ADDENDUM NO. 1

VILLAGE OF LAURA MIAMI COUNTY, OHIO STANDBY GENERATOR October 22, 2024

Re: Village of Laura
Standby Generator

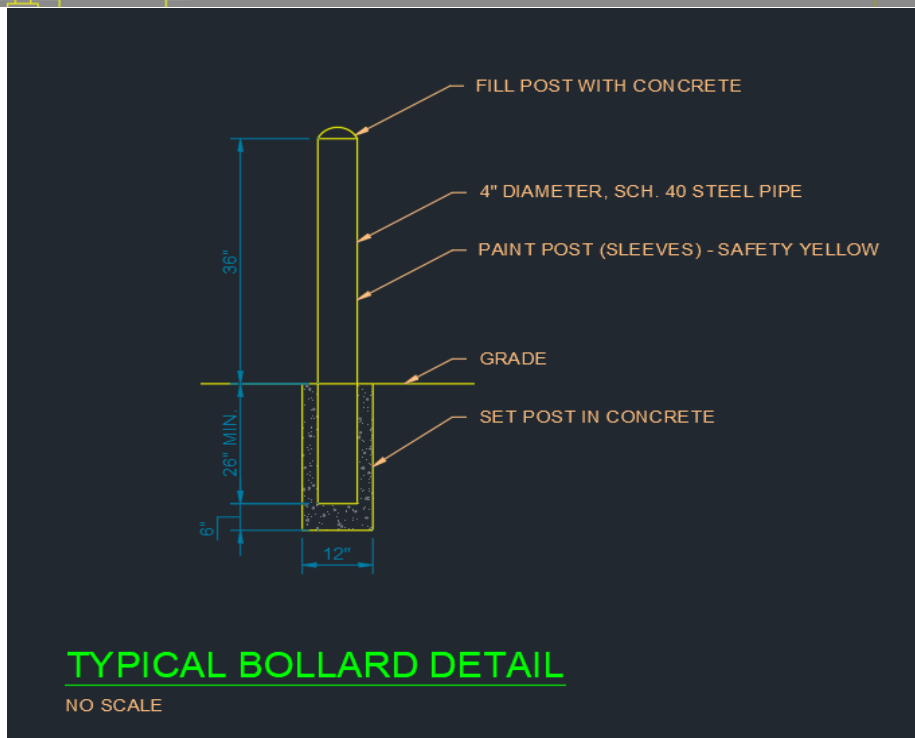
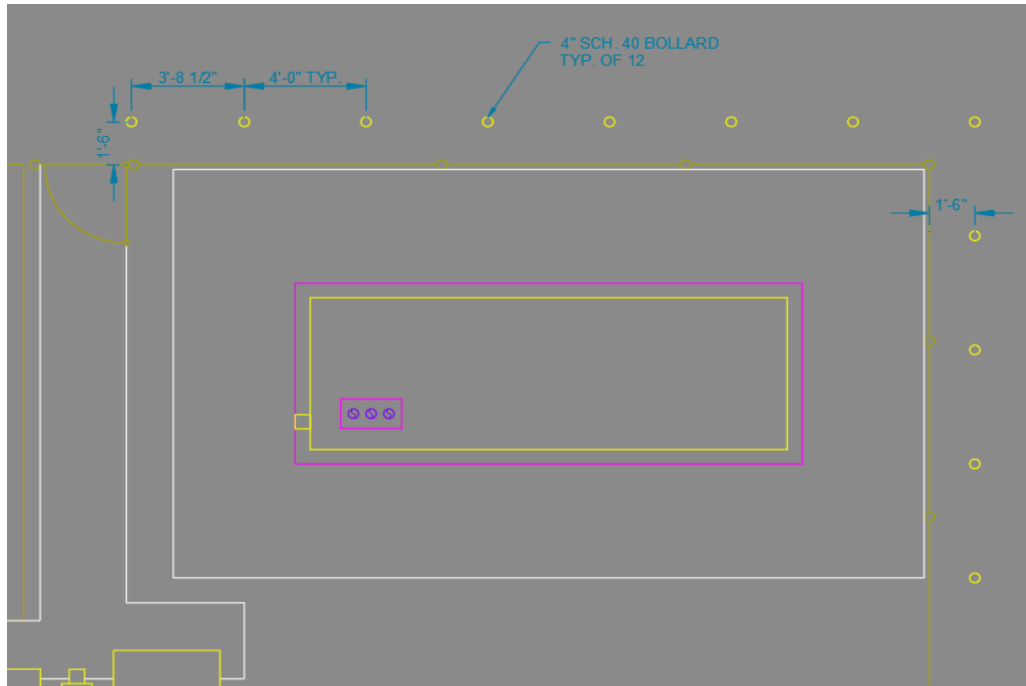
2. Should the targeted completion date of April 1, 2025, not be attainable due to product lead times, please note your required time extension in your bid. This time will be used to make adjustments for the target completion date once the project has been awarded.
3. The generator placement will require 12 bollards to be placed 18" on the outside of the fence as seen in the sketch below. The bollards shall be 4" diameter schedule 40 steel pipe per the typical bollard detail below.
